241-S-102 WORK PACKAGE AND QUALITY CONTROL ACCEPTANCE INSPECTION

STANDARD WORK ORDER CLO-WO-07-1840**S-102, Remove Remaining Miscellaneous Equipment****1.0 SCOPE**

9. Title Replace Breather Filter with Radial Breather Filter		10. Bldg. / Facility No. 241S/241-S-102	11. Equipment / Component ID S102-WST-FLT-101	12. Approval Designator E

Document/Drawing No. H-14-106151 Sheet 2 Revision 2

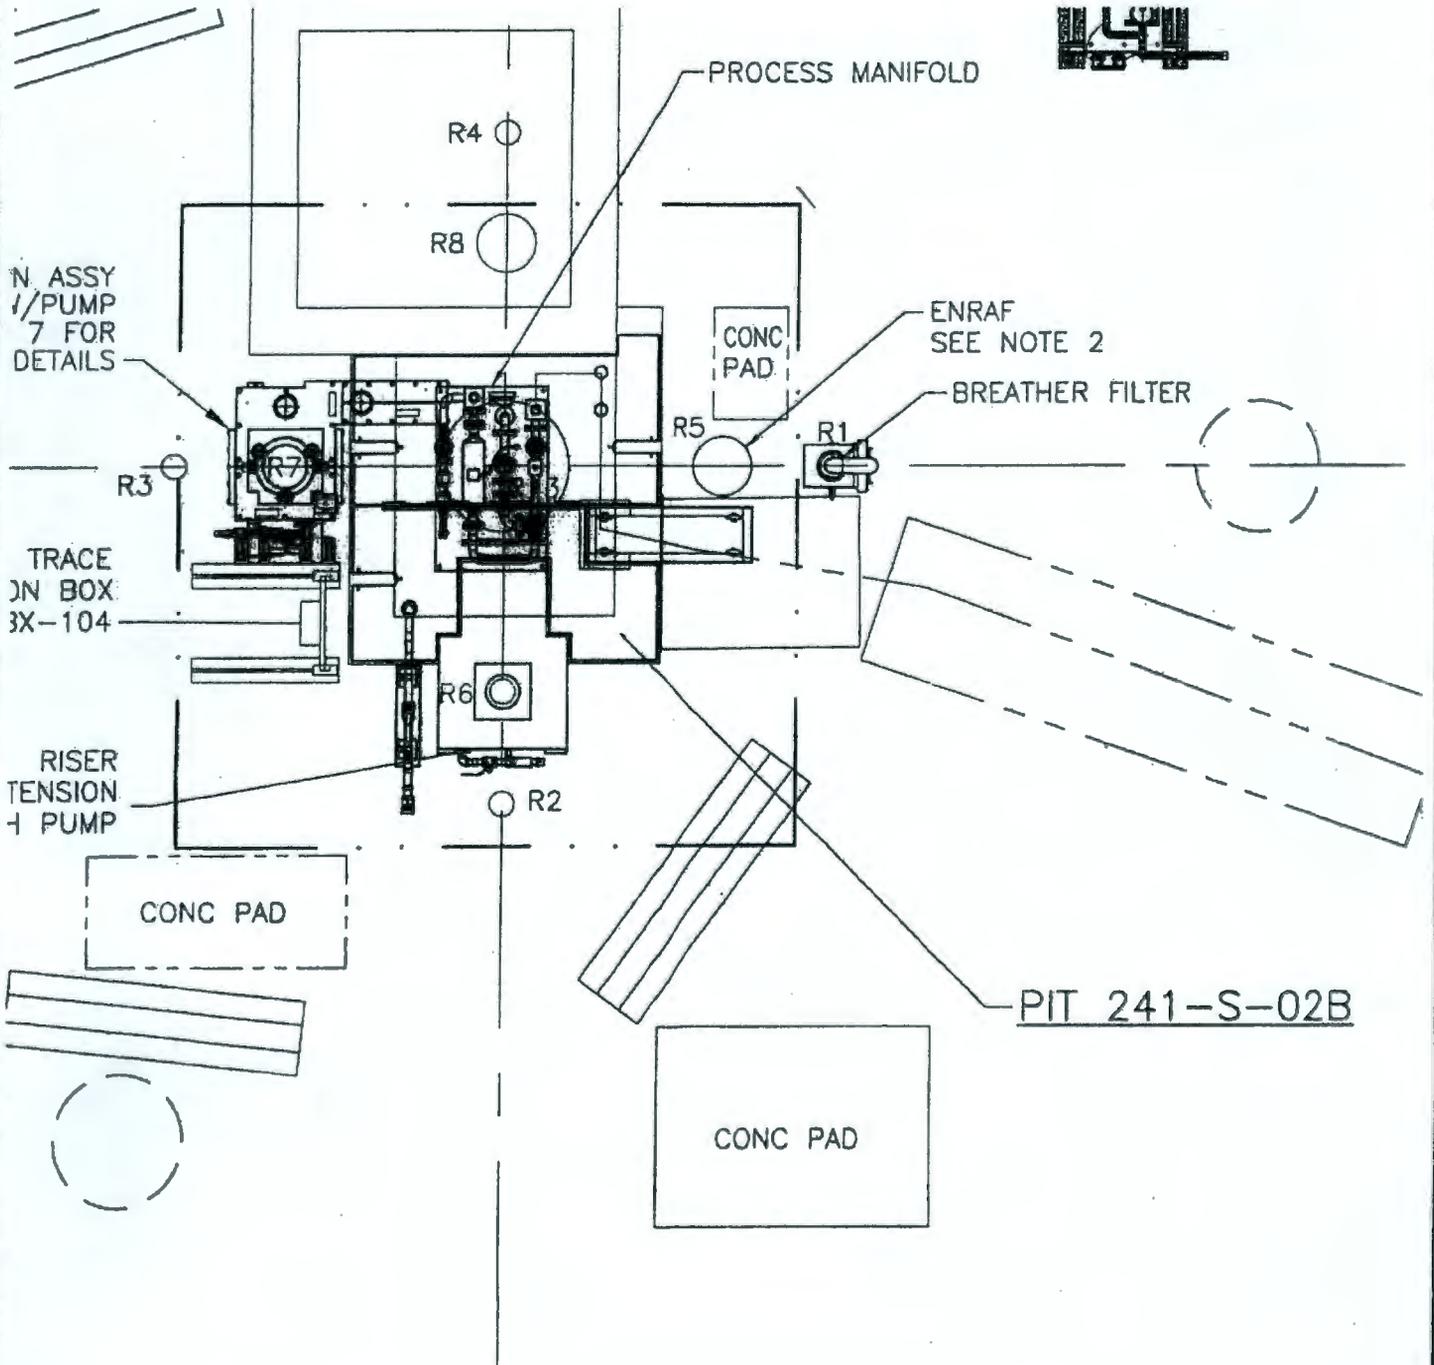
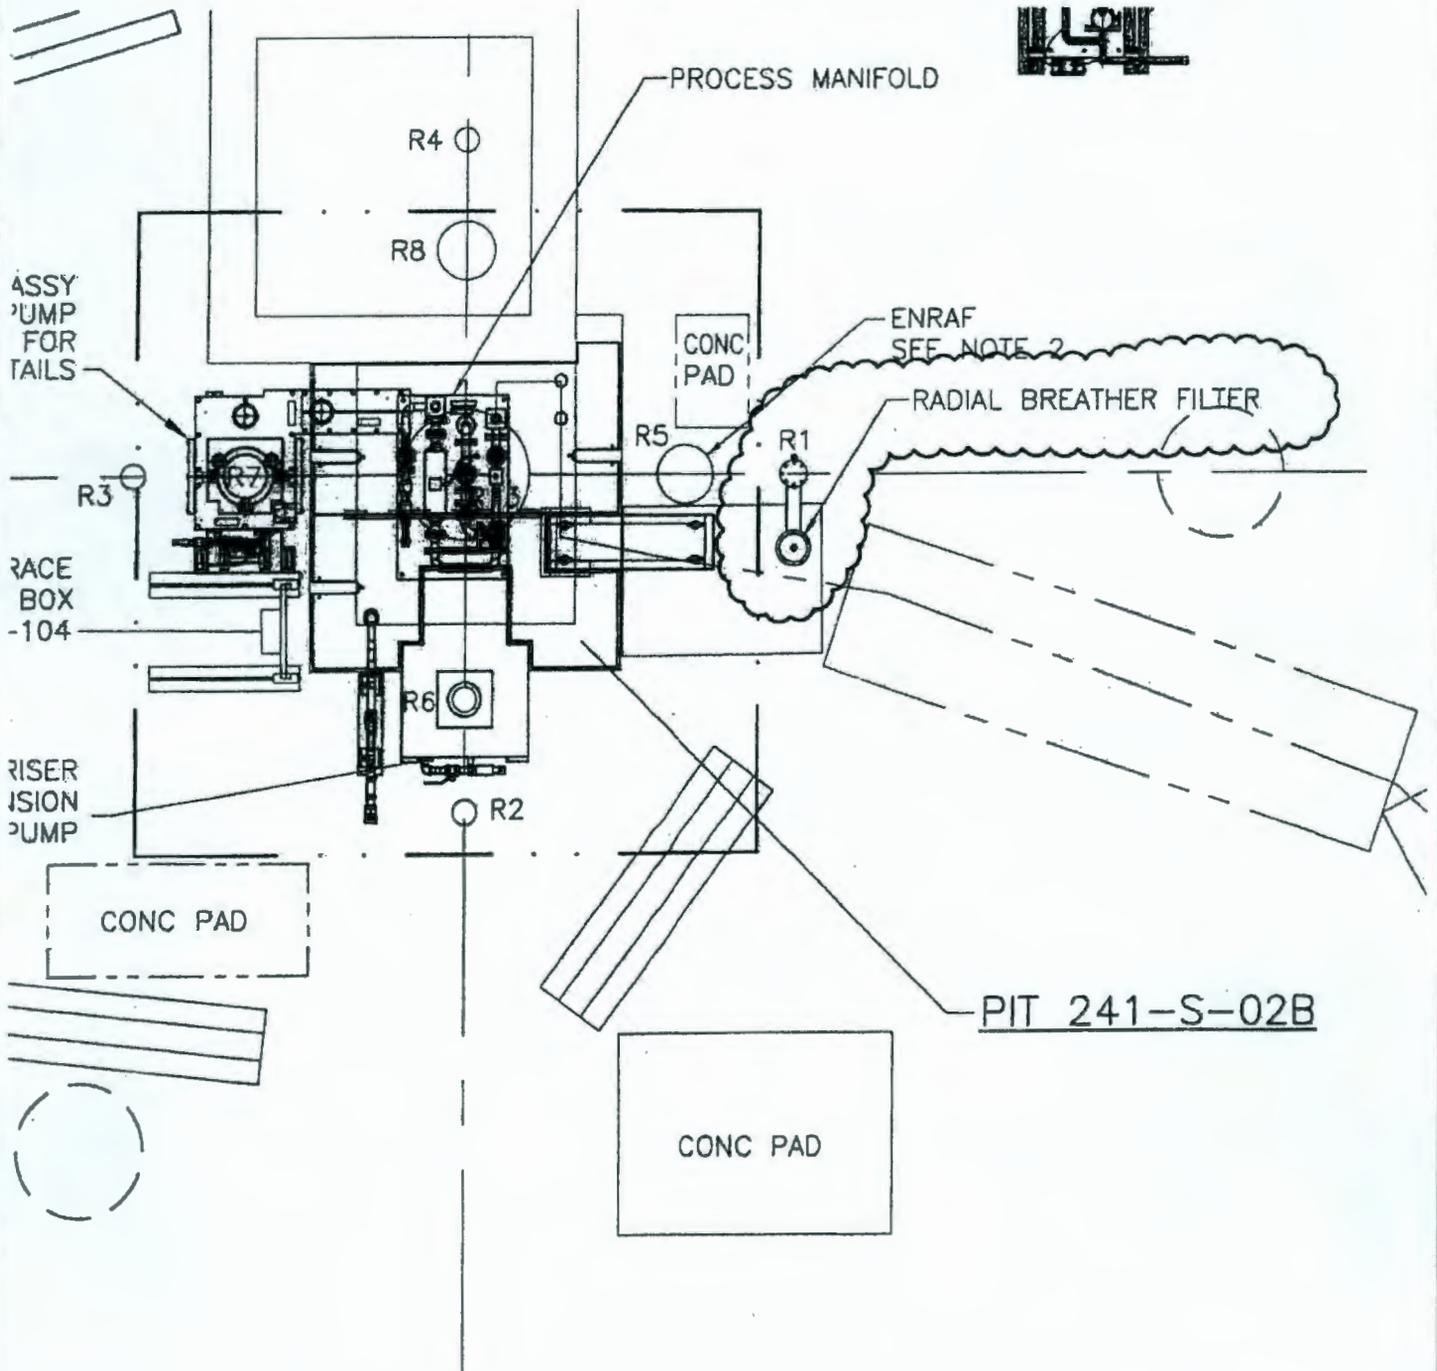
H-14-106151 Sh 2: Change the Civil Site Plan to pictorially depict a radial breather filter on Riser 1 as shown on pages 6 and 7 of this ECN.

WAS: ZONE C5-D6, PER ECN-724952-R1, OTHER
OUTSTANDING ECNS DO NOT AFFECT THIS MODIFICATION

IS: REVISE DRAWING TO PICTORIALLY DEPICT RADIAL BREATHER FILTER
INSTALLED IN RISER 1 AS SHOWN:

Document/Drawing No. H-14-106151 Sheet 5 Revision 3

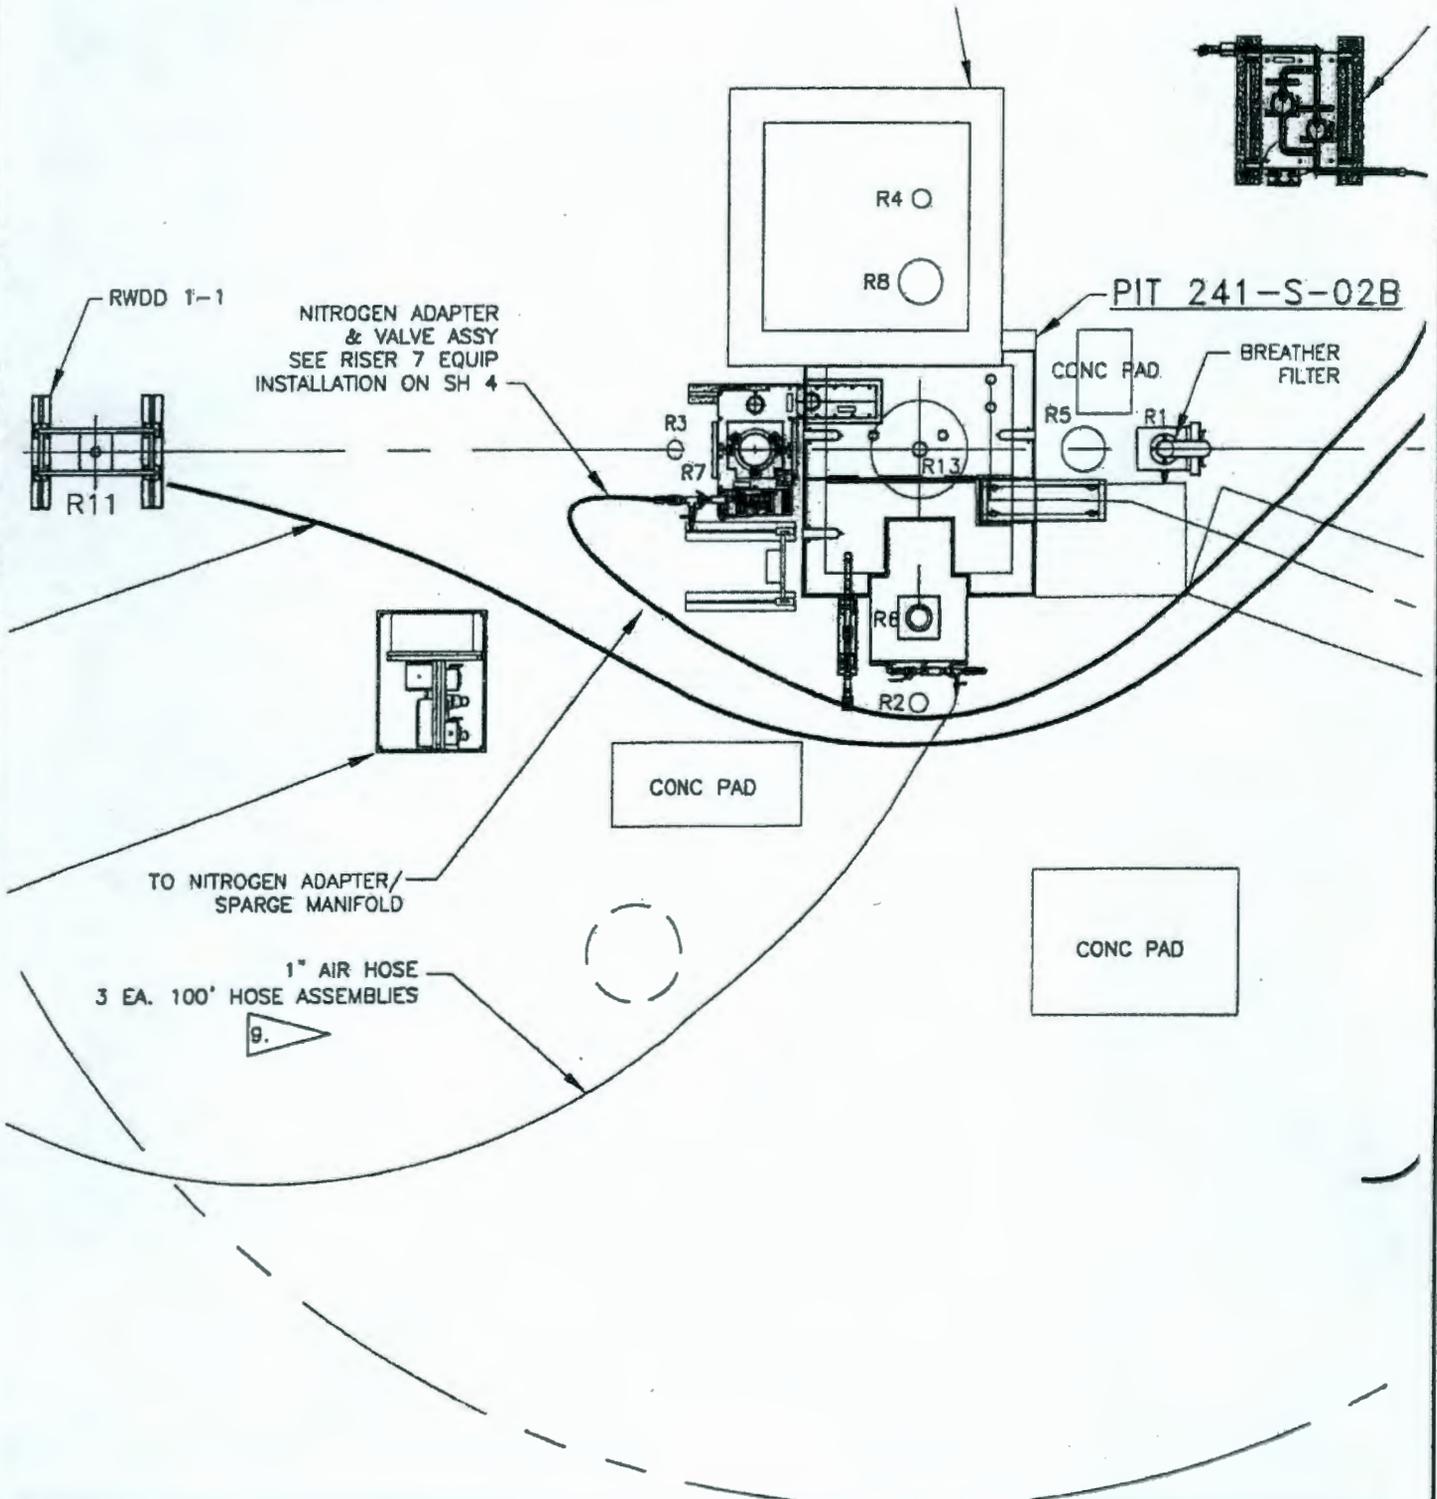
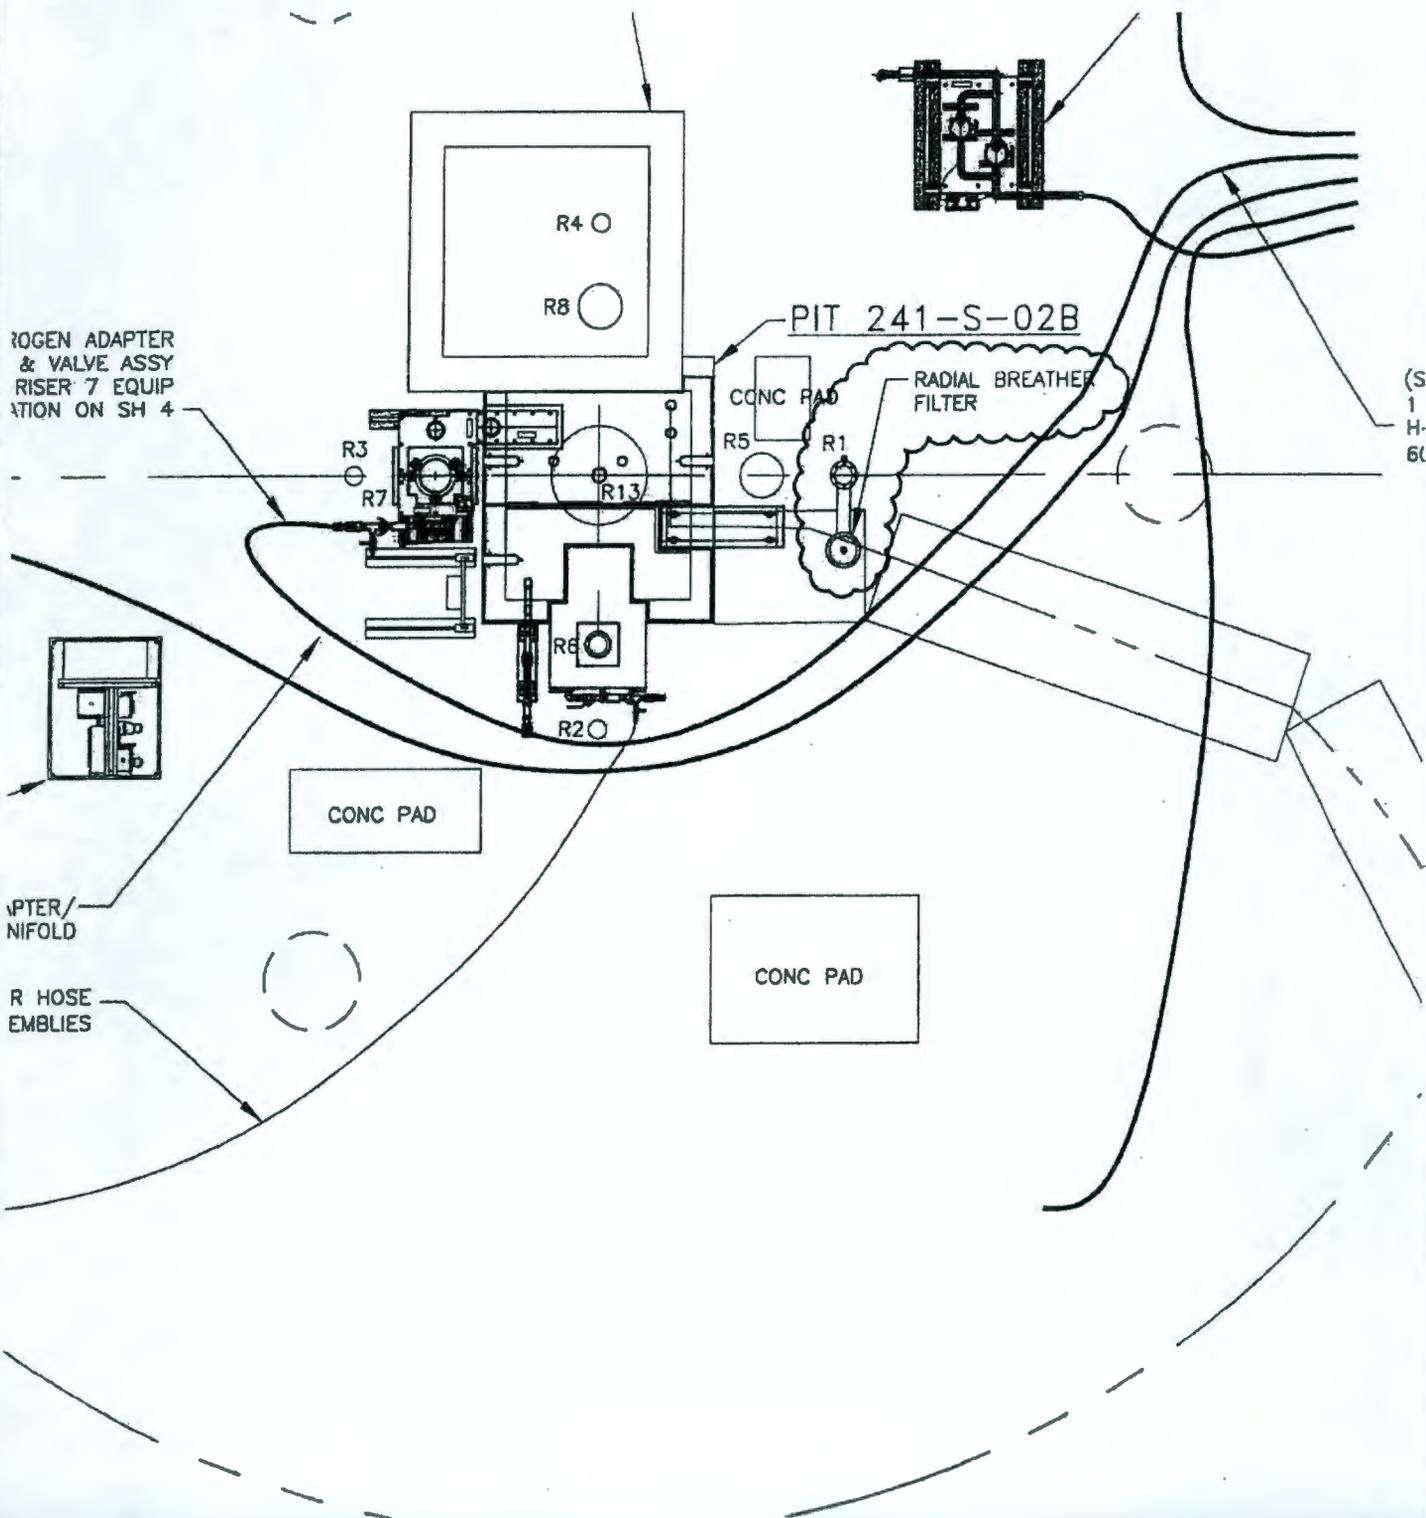
H-14-106151 Sh 5: Change the Civil Site Plan to pictorially depict a radial breather filter on Riser 1 as shown on page 8 and 9 of this ECN.

WAS: ZONE C5-D6,
OUTSTANDING ECNS DO NOT AFFECT THIS MODIFICATION

IS: REVISE DRAWING TO PICTORIALLY DEPICT RADIAL BREATHER FILTER
INSTALLED IN RISER 1 AS SHOWN:

Sheet 1

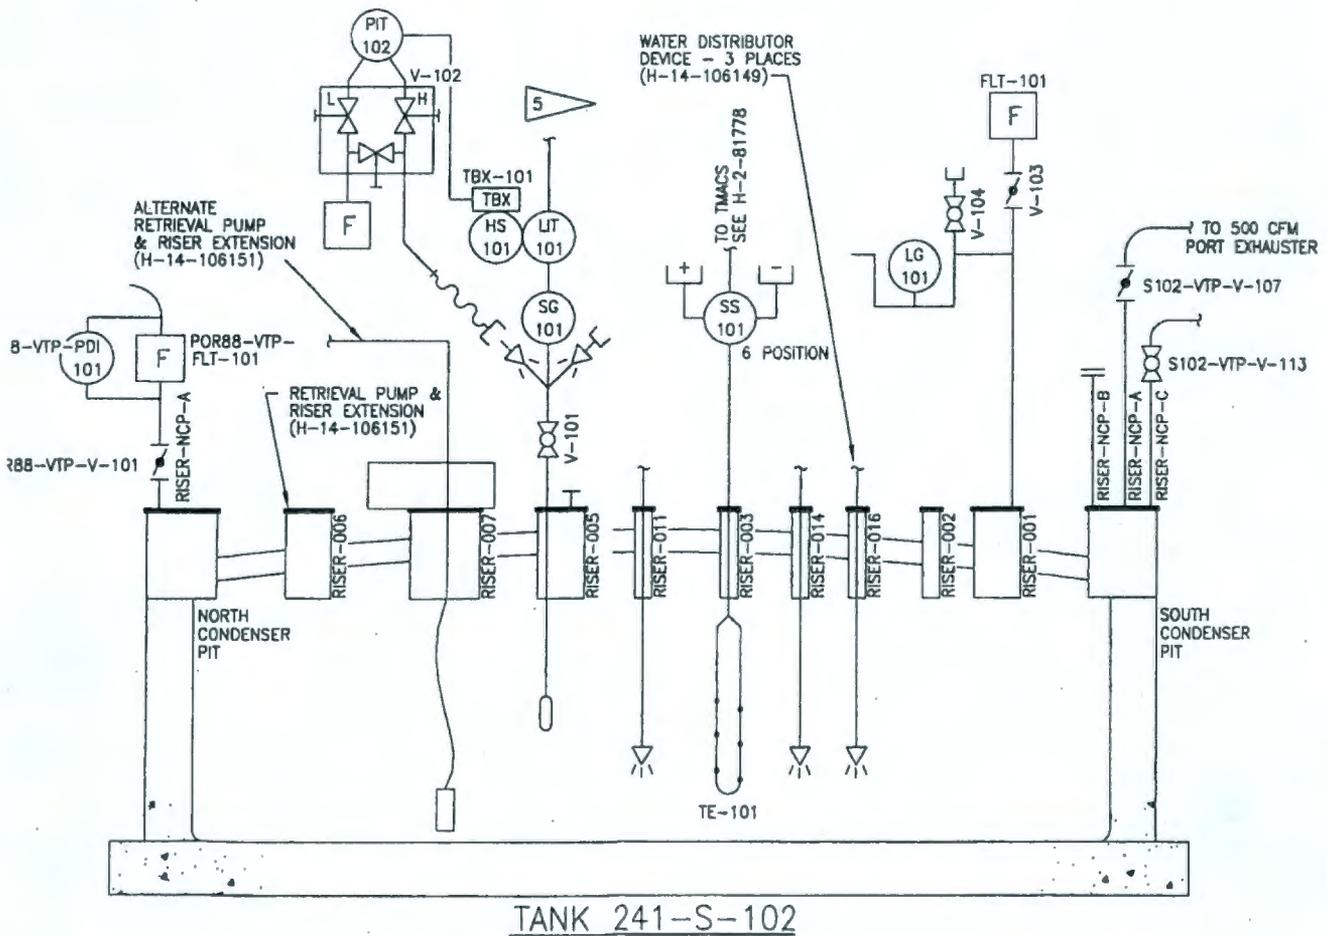
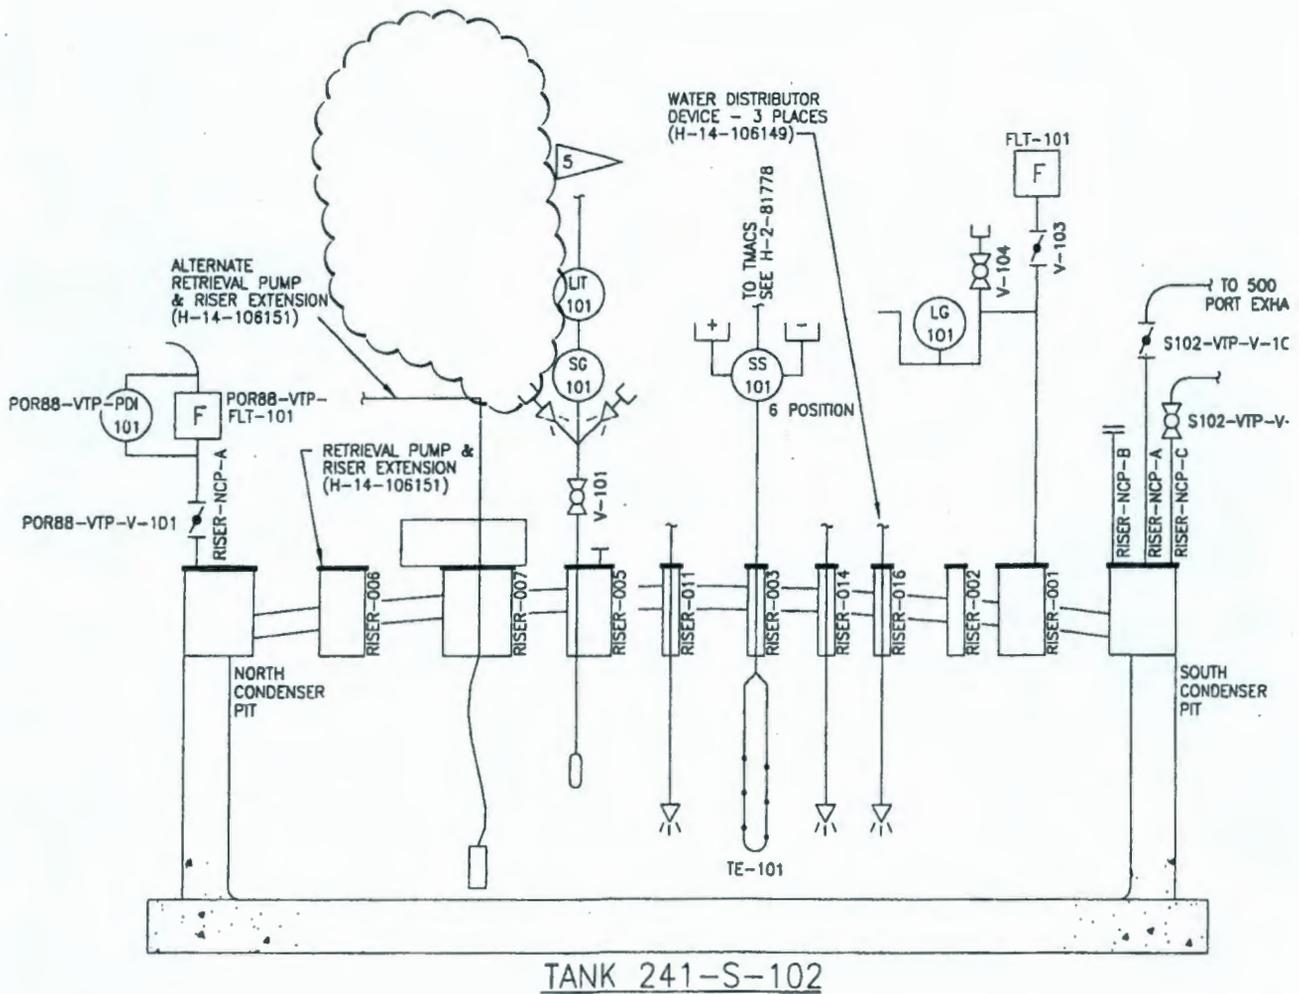
WAS: INCORPORATES ECN-724065-R1 & 724956-R1

IS: INCORPORATES ECN-724065-R1 & 724956-R1
